**COLORADO DIVISION OF RECLAMATION, MINING AND SAFETY
MINERALS PROGRAM INSPECTION REPORT
PHONE: (303) 866-3567**

MINE NAME: Dawson Gold Project	MINE/PROSPECTING ID#: P-2013-002	MINERAL: Gold	COUNTY: Fremont
INSPECTION TYPE: Mineral Prospect Inspection	INSPECTOR(S): Timothy Cazier, P.E.	INSP. DATE: September 15, 2021	INSP. TIME: 10:30
OPERATOR: Zephyr Gold USA Ltd	OPERATOR REPRESENTATIVE: John Kratz & Angela Bellantoni	TYPE OF OPERATION: MP - Mineral Prospecting

P-2013-002 Dawson Gold Project 2021 Post Inspection Map

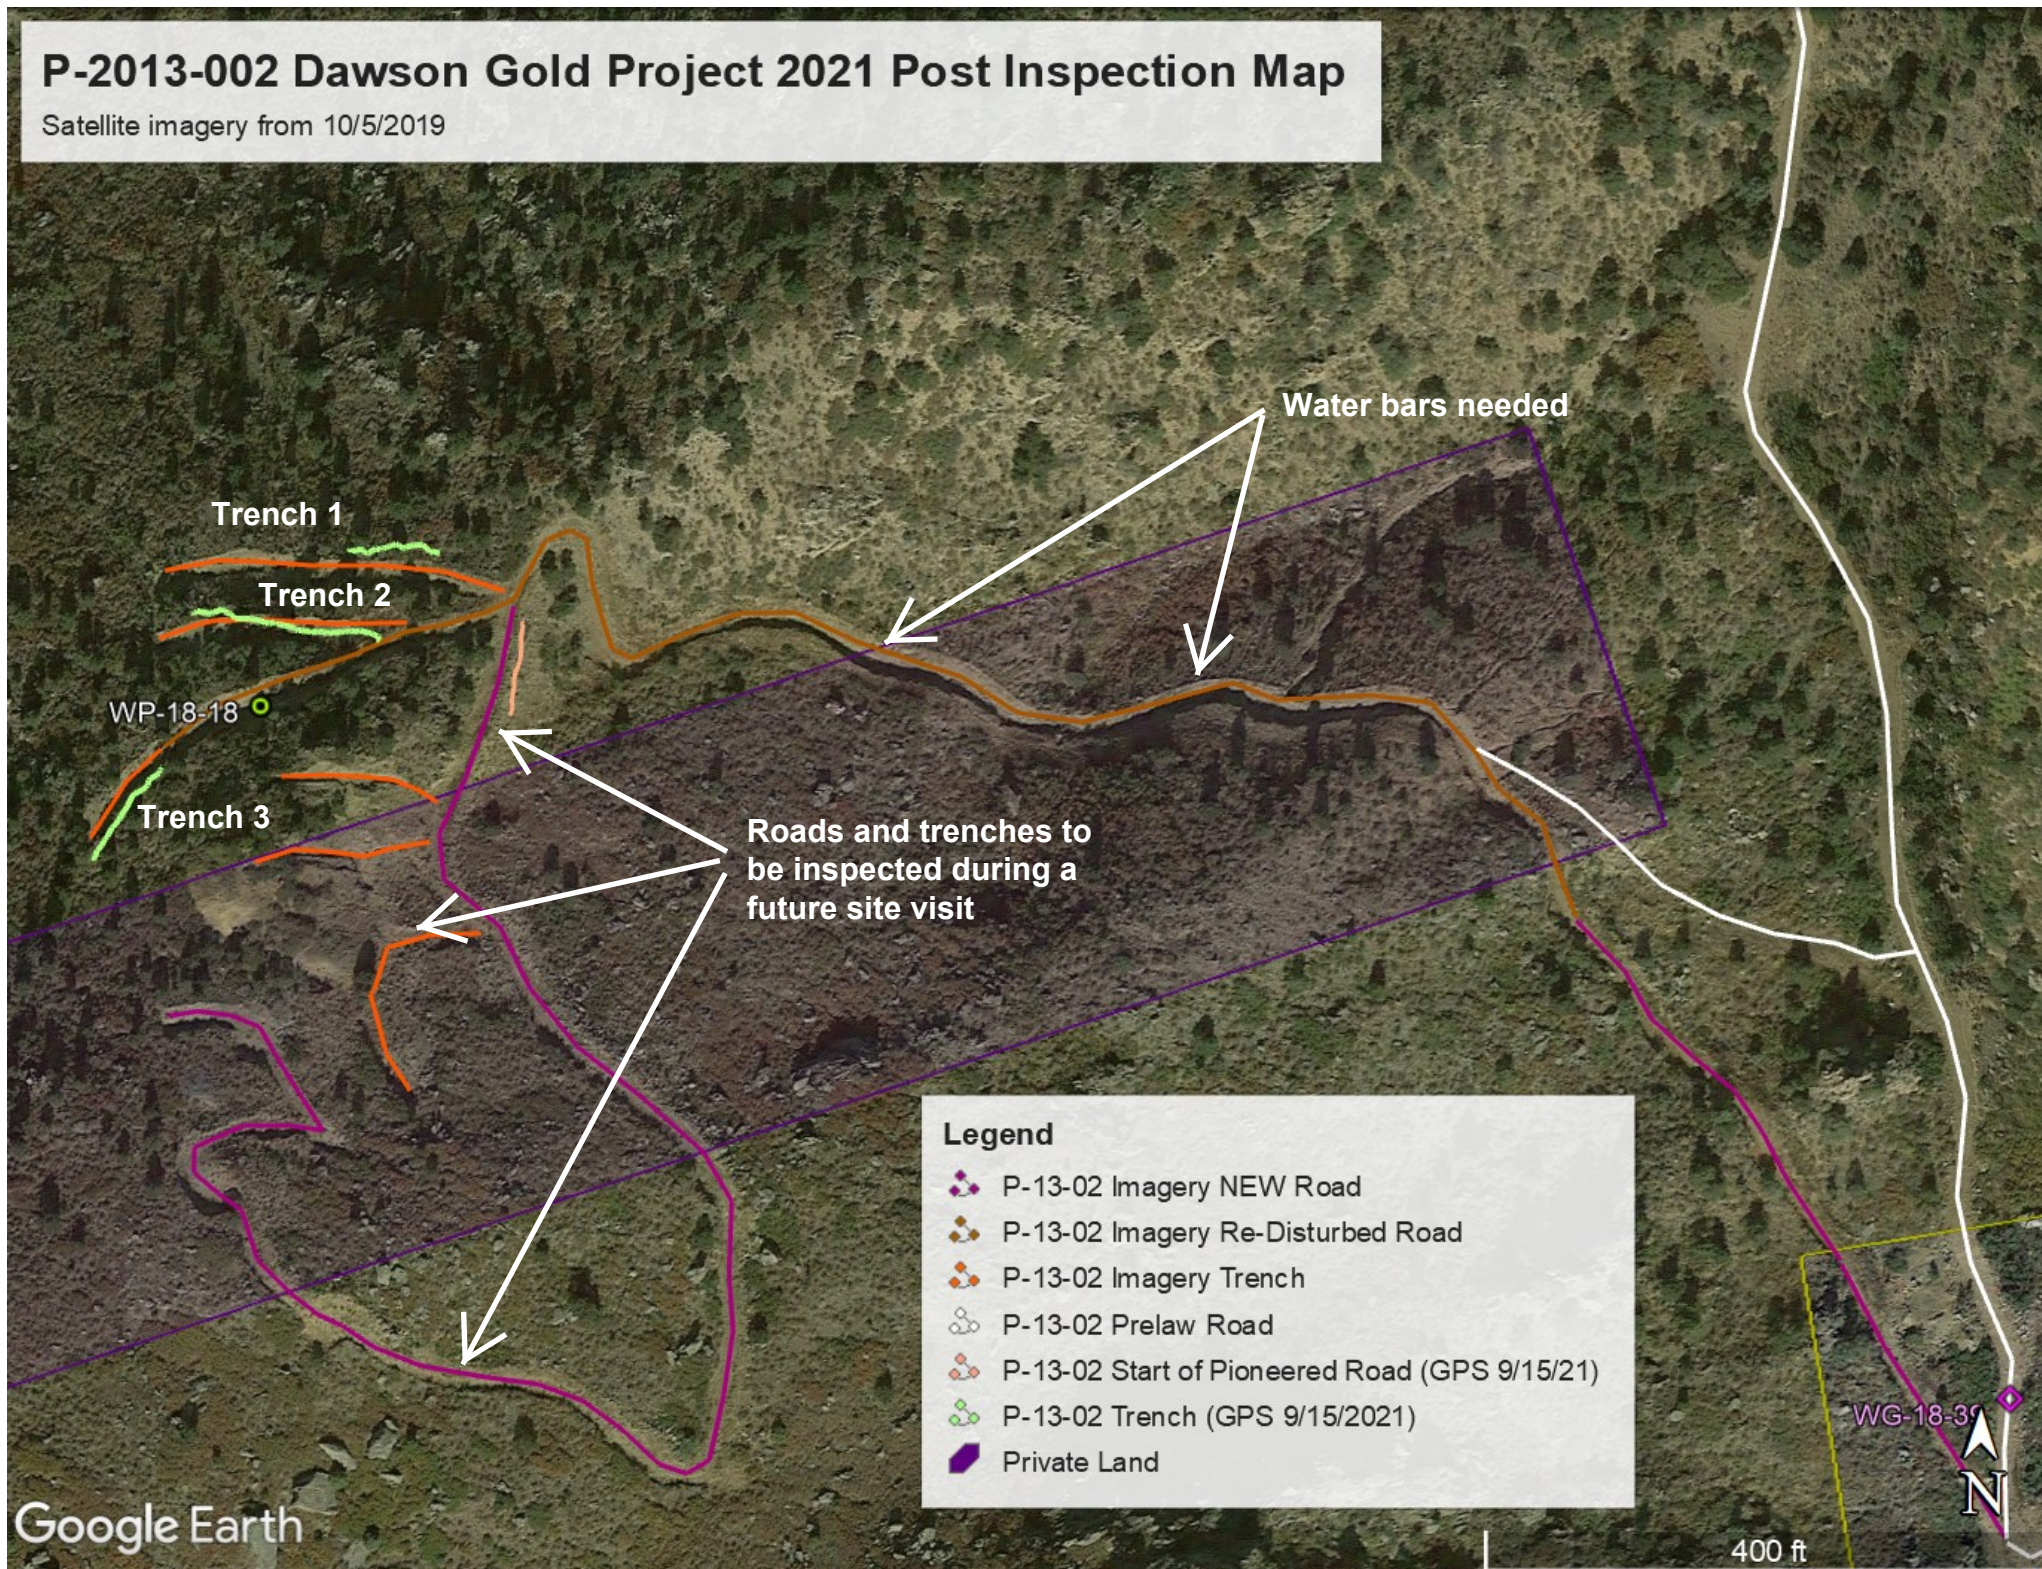
Backfilling and Grading: Trenches 1 (see **Photo 1**), 2 (see **Photo 2**) and 3 (see **Photo 3**) had been backfilled. Additional roads and/or trenches up the hill to the south (see **Photo 4**) were not investigated due to time constraints, but will be visited during a future inspection. The attached **Post Inspection Map** shows the locations of the three trenches.

Roads: A comparison of historic Google Earth imagery demonstrates which roads in the area inspected are new (magenta lines on the **Post Inspection Map**) and re-disturbed, previously reclaimed access roads (brown lines on the **Post Inspection Map**). All these roads will need to be backfilled per the approved NOI.
